CINTICHEM, INC.
P.O. BOX 816
TUXEDO, NEW YORK 10987 (914) 351-2131

March 8, 1991

The above referenced correspondence pertains to a Cintichem proposal to modify the decommissioning project whereby certain tasks may be started while reactor fuel remains on site. It was resolved in a recent meeting between NRC and Cintichem, that is documented in Reference (2), that certain modifications to the Decommissioning Plan would be required. Those modifications as listed below are hereby submitted for review and approval. The Plan sub section numbers are cross-referenced to the task item numbers that were originally proposed in Reference (1).

REACTOR POOL PLAN.

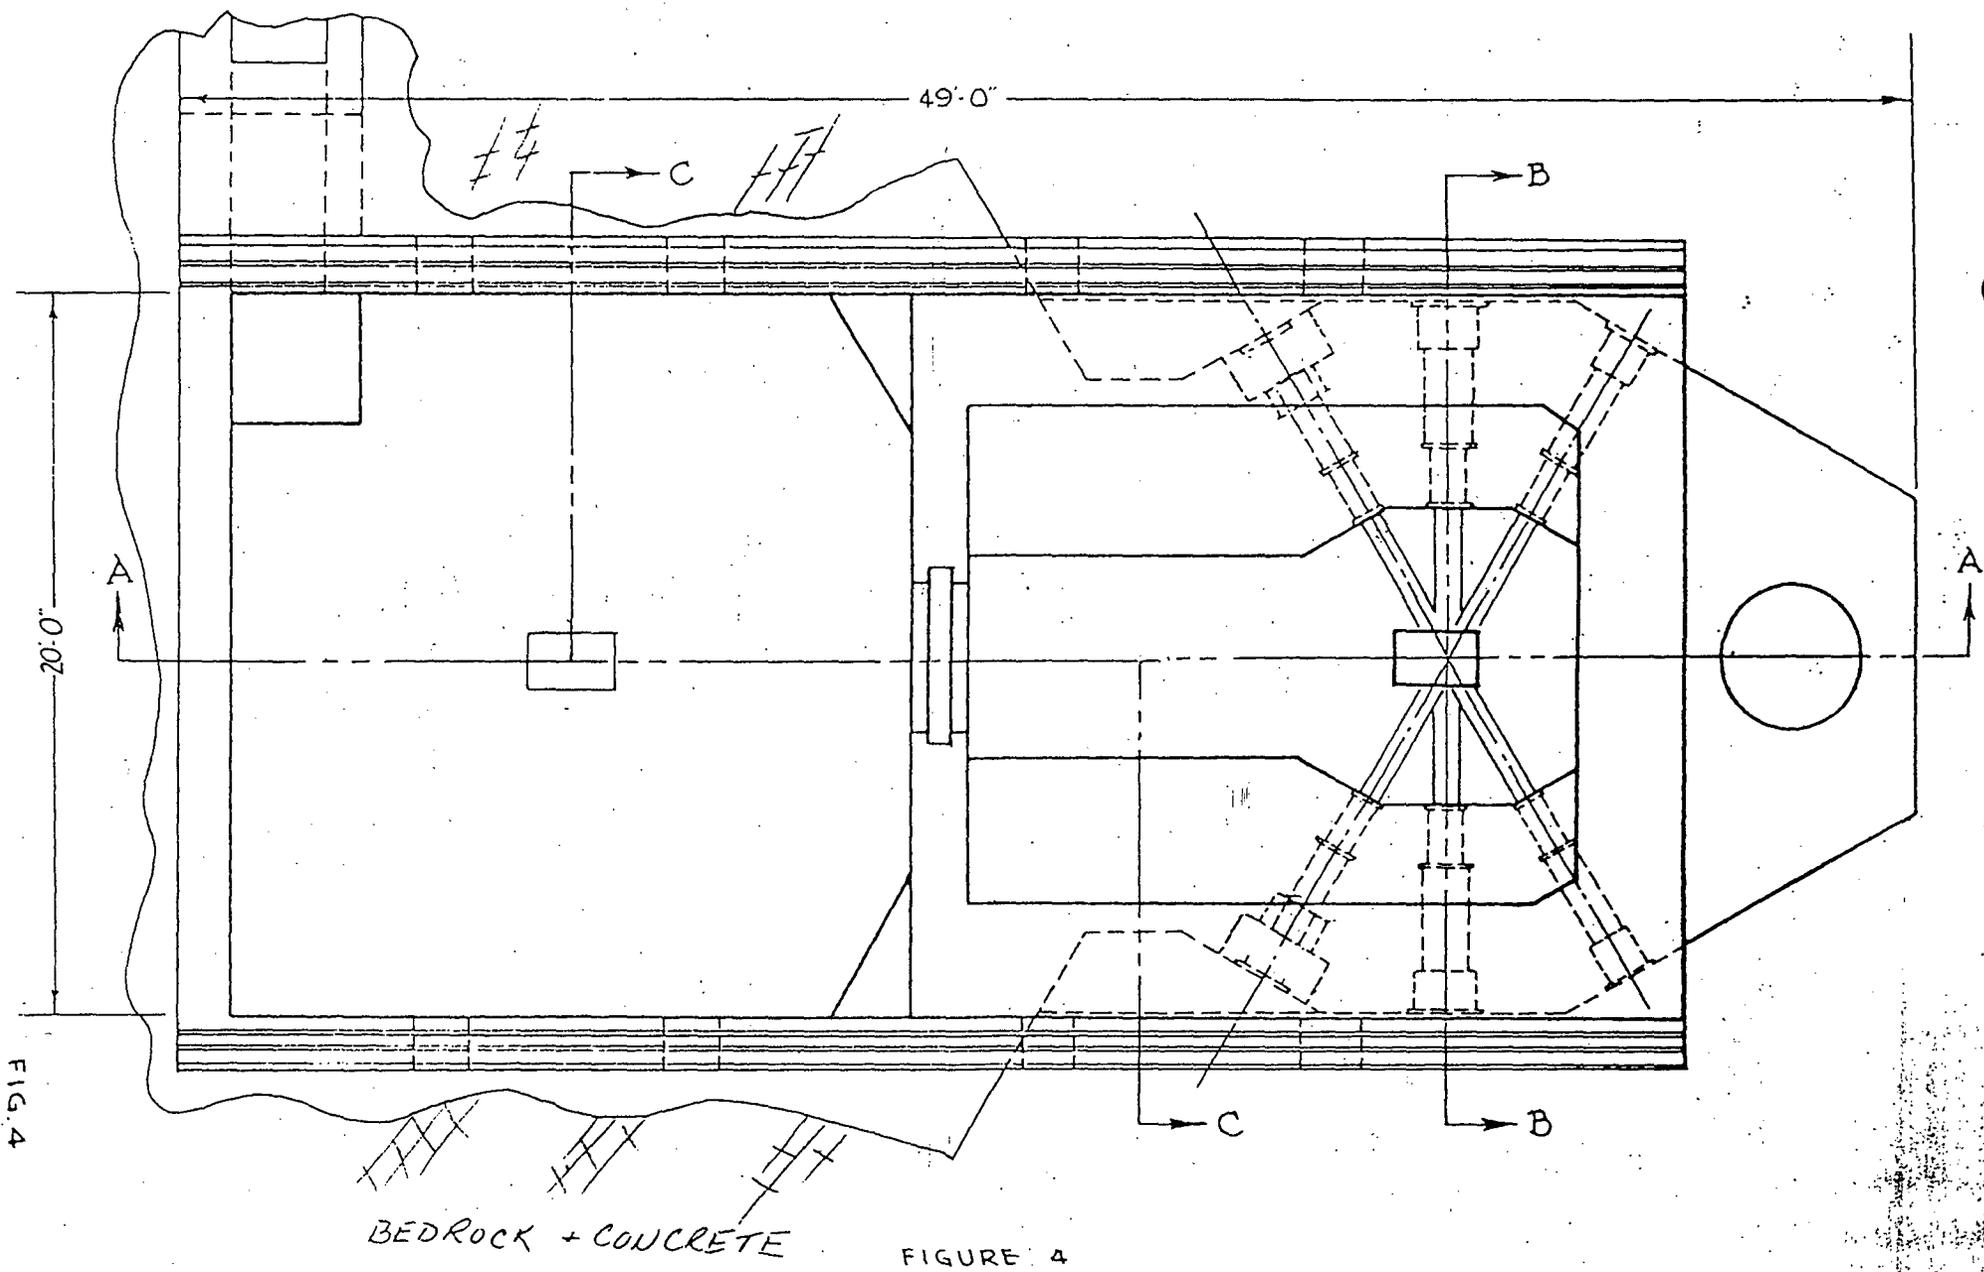
There are no other pathways for inadvertent drainage of the pool. Figures 4 and 5 are a plan view and elevation respectively of the reactor pool and stall at the upper level. The pool is built into bedrock except for the east side. This side is comprised of the berm and the dam. Except for the core coolant outlet and return pipes there are no penetrations.

The original task has been changed only with respect to isolating the stall from the pool while the task is being accomplished. This is necessary to assure the integrity of the fuel storage conditions in the pool. The actual work involved in removal of the core structures will be conducted as originally described in the Decommissioning Plan.
